APPENDIX A. HCC S278 Pre-Application Design Review Report

Lovedean Lane, Horndean

Pre-Application Design Review Report

Job No: R.J505862 (JZA1U)
Report No: R.J505862 -A

DRAWING No:				REV	
ITB11383-GA-101				C

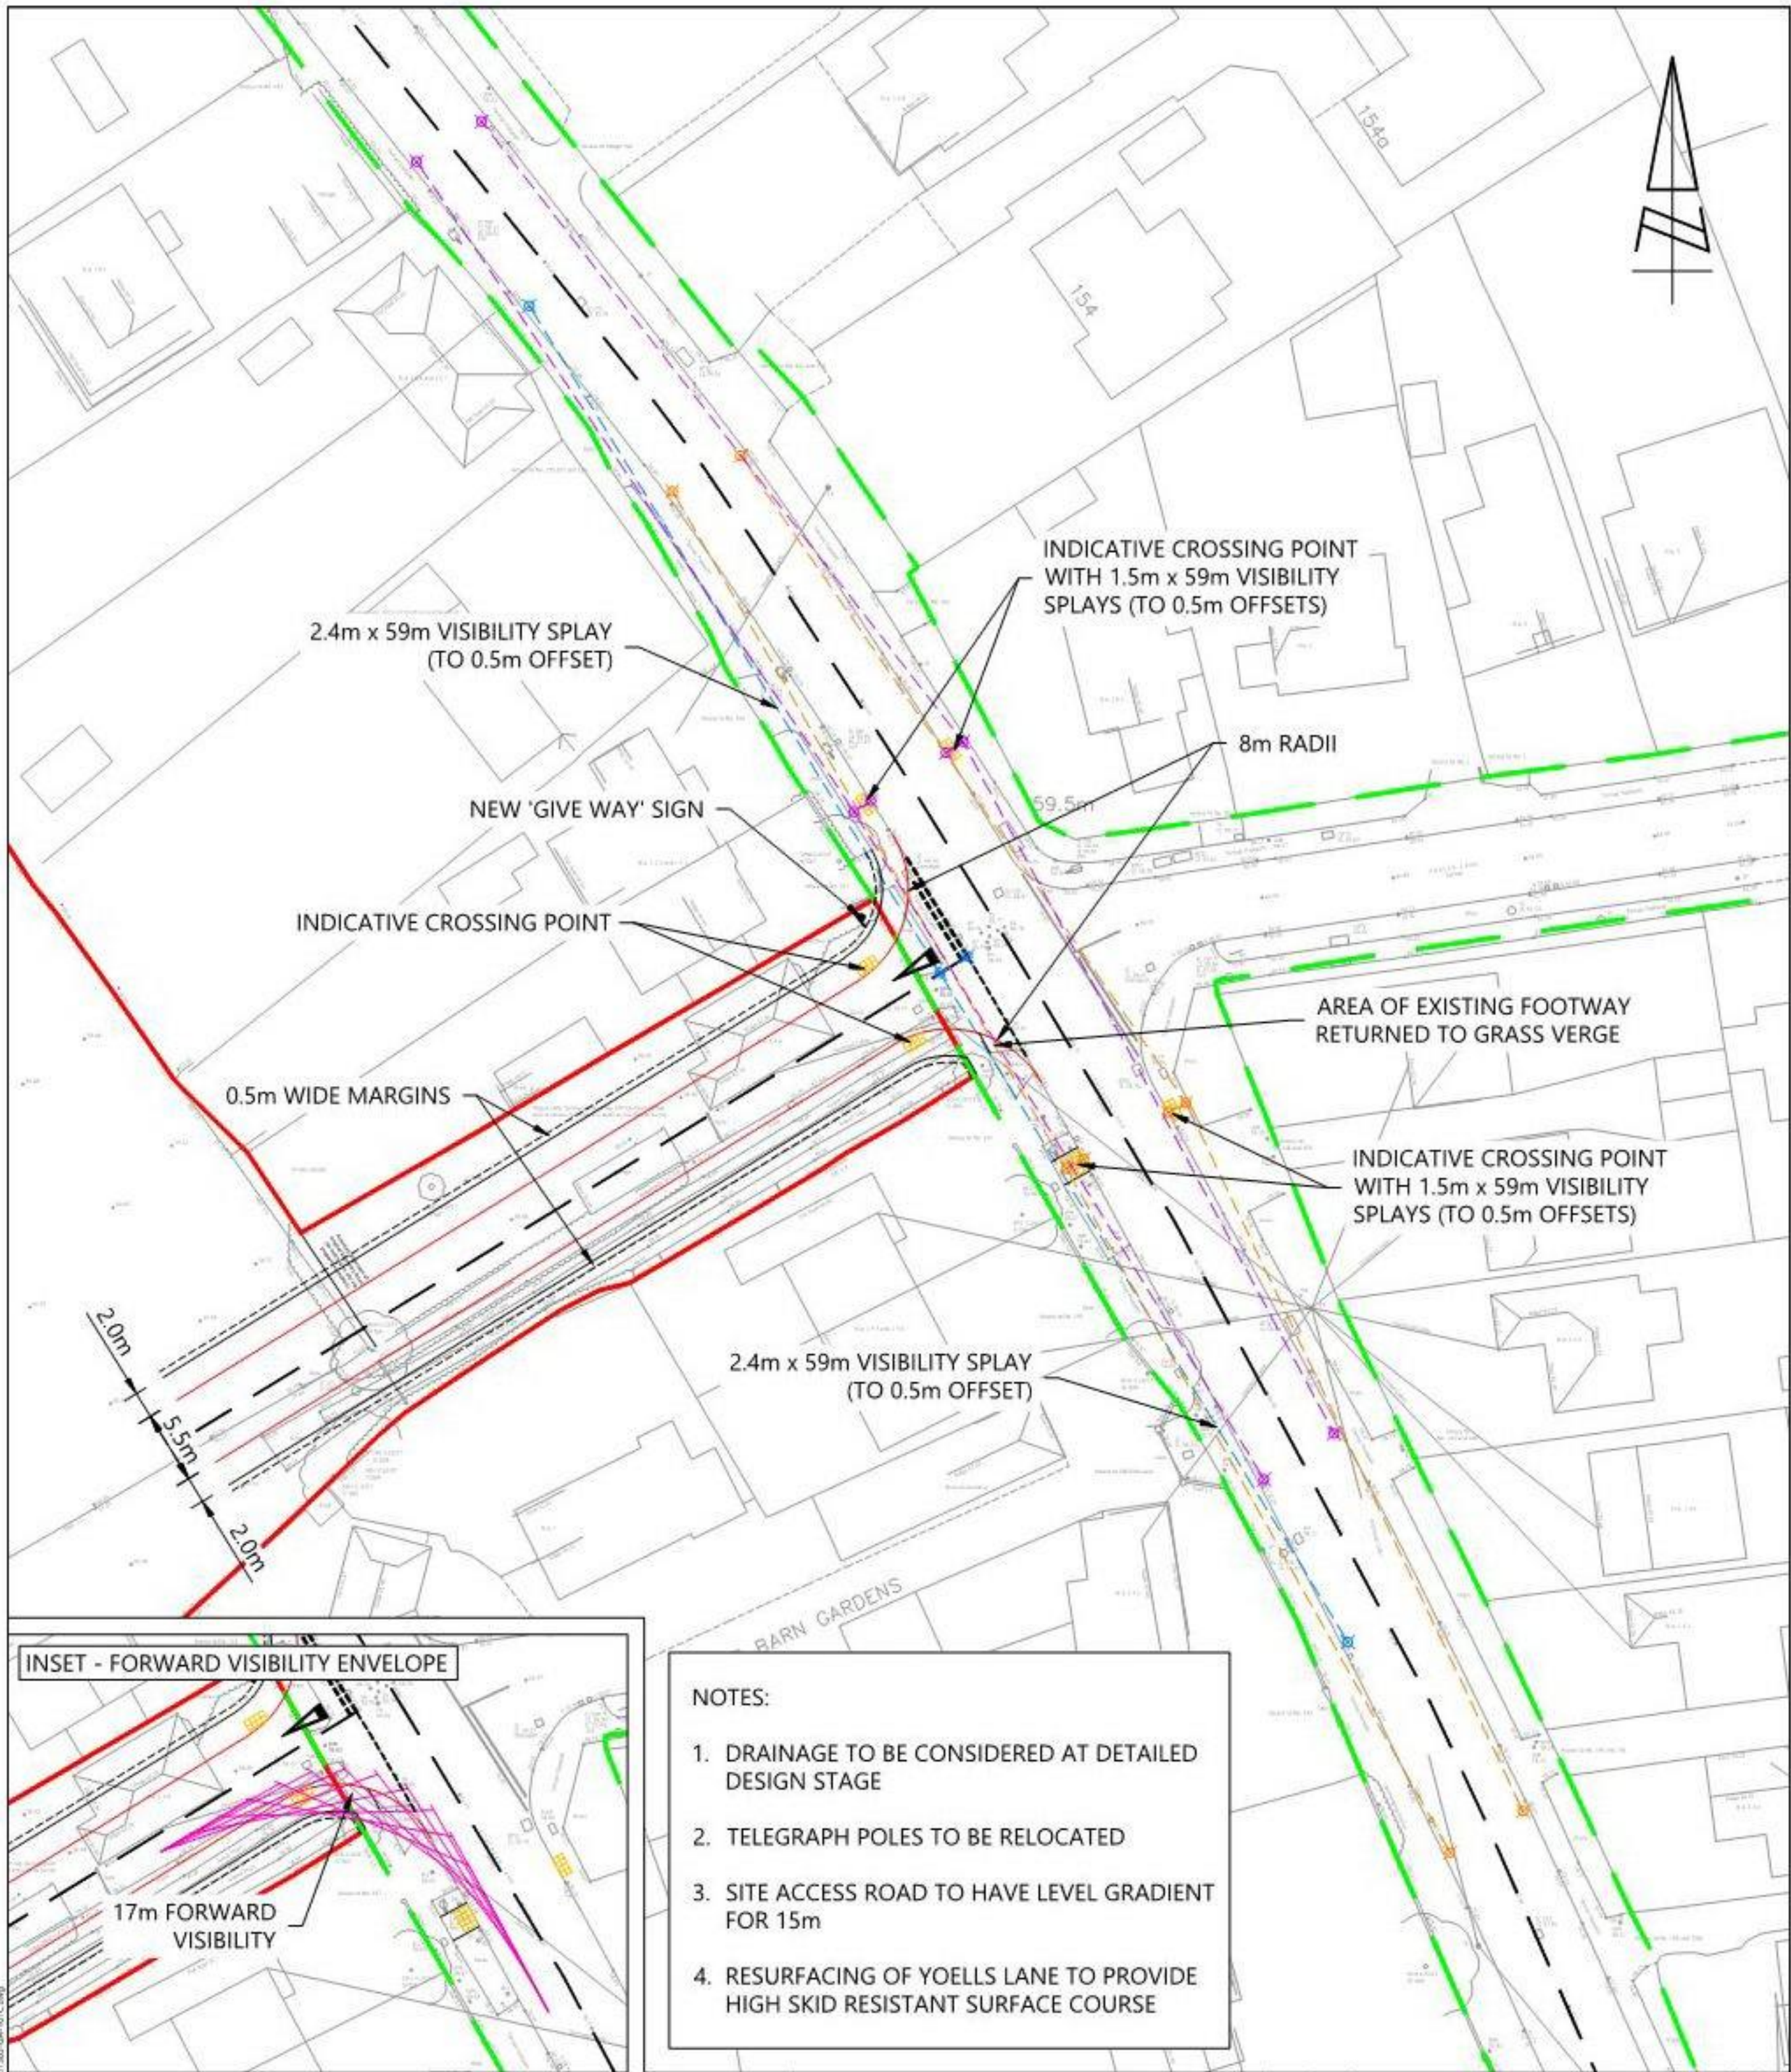
Location of proposed priority junction is opposite the existing Yoells lane junction, thus creating a crossroads. Referring to Table 2/1 in TD42/95, a crossroads junction is considered an appropriate type of junction in this situation.

There is concern that the new junction may create a see through issue when approaching from the Yoells Lane arm, which is also raised in the Stage 1 Road Safety Audit.

From site observation on the 15th April 2016, the proposed site access will have an uphill gradient approach. Referring to 3.6 and 3.7 TD42/95, a level section of 15m should be created adjacent to the major road.

The approach on Yoells lane arm to the major road has significant downhill approach, due to land constraints it is not feasible to re-grade the approach. However it should be considered at the Preliminary and detailed design stages, to resurface the approach of Yoells Lane with high skid resistant surface course. This should be at least 15m into the junction.

Given the vertical alignment of Yoells Lane, naturally a significant amount of surface water falls towards Lovedean Lane. With the proposals creating a crossroads, the drainage at the entire crossroad junction should be assessed and upgraded as required at the preliminary and detailed design stages.

With the creation of a crossroads, the junction should be unobscured by any significant street furniture such as Telegraph poles which are currently sited within the junction area. In addition, parking restrictions should be considered to ensure that junction intervisibility is provided between all arms and proposed pedestrian crossing points.

It is suggested that the proposed access is located far south as possible, this would move the junction away from the sightline from the straight section of Yoells lane. In addition, signing and roadmarking measures should be introduced to highlight that there is a Give way priority junction ahead.

- NOTES:
1. DRAINAGE TO BE CONSIDERED AT DETAILED DESIGN STAGE
 2. TELEGRAPH POLES TO BE RELOCATED
 3. SITE ACCESS ROAD TO HAVE LEVEL GRADIENT FOR 15m
 4. RESURFACING OF YOELLS LANE TO PROVIDE HIGH SKID RESISTANT SURFACE COURSE
